Groundwater Application Review Summary Form

Application # G- 19199 GW Reviewer <u>James Hootsmans/Travis Brown</u> Date Review Completed: <u>October 24, 2022</u> **Summary of GW Availability and Injury Review:** ☐ Groundwater for the proposed use is either over appropriated, will not likely be available in the amounts requested without injury to prior water rights, OR will not likely be available within the capacity of the groundwater resource per Section B of the attached review form. **Summary of Potential for Substantial Interference Review:** There is the potential for substantial interference per Section C of the attached review form. **Summary of Well Construction Assessment:** The well does not appear to meet current well construction standards per Section D of the attached review form. Route through Well Construction and Compliance Section. This is only a summary. Documentation is attached and should be read thoroughly to understand the basis for determinations and for conditions that may be necessary for a permit (if one is issued).

Application G-19199

Date: 10/24/2022

Water-Level Measurements in Nearby Wells

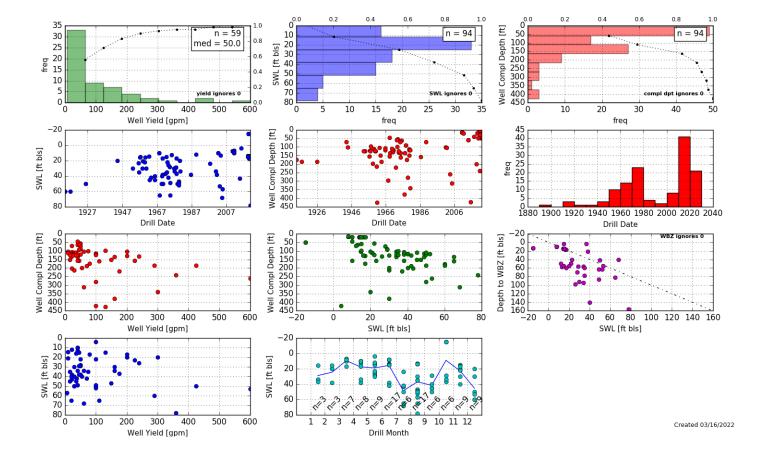
Basis for aquifer hydraulic connection evaluation: The elevation of groundwater in nearby observation wells with comparable construction to the proposed POA is similar to the elevation of nearby surface water (see Hydrograph, attached). Groundwater surface mapping in this area indicates that groundwater is generally flowing towards the small streams and reservoirs which drain into Rock Creek (Gannett and Caldwell, 1998).

Theis Model

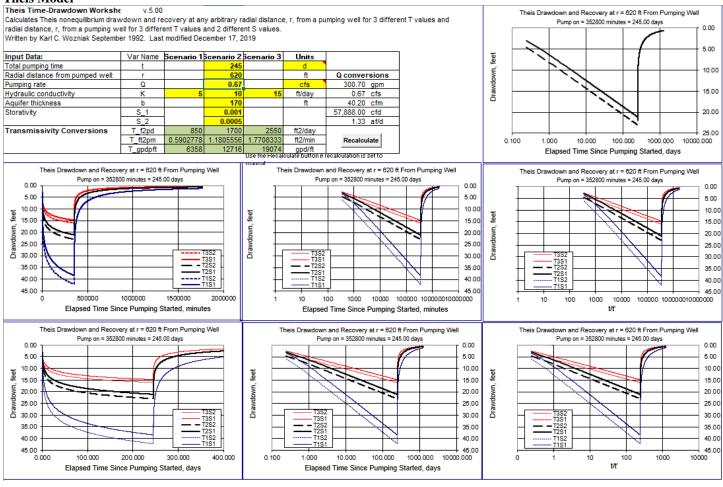
A Theis (1935) drawdown analysis was conducted to assess the potential well-to-well interference with CLAC 2538 due to pumping of the proposed POA in the amounts requested. Hydraulic parameters used for the analyses were derived from regional data and studies (Pumping Test Reports; Conlon et al., 2003, 2005; Iverson, 2002; Woodward et al., 1998) or are within a typical range of values for the parameter within the hydrogeologic regime (Freeze and Cherry, 1979).

Results indicate that the proposed use is not likely to cause well-to-well interference with CLAC 2538 that exceeds the threshold under the standard condition for alluvial aquifers in the Willamette Basin.

Water Availability Tables

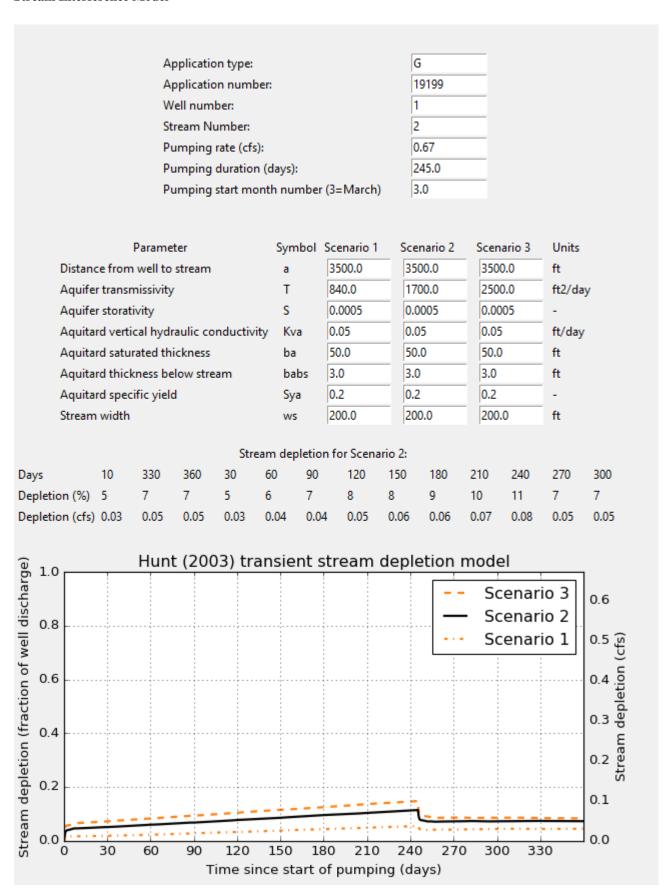
Comments: C3a: The proposed rate of appropriation (0.67) is just below 1 percent (0.673 cfs) of the natural flow that is equaled or exceeded 80 percent of the time (67.3 cfs) for the PUDDING R > MOLALLA R – AB MILL CR Water Availability Basin (WAB) (see Water Availability Tables, attached).
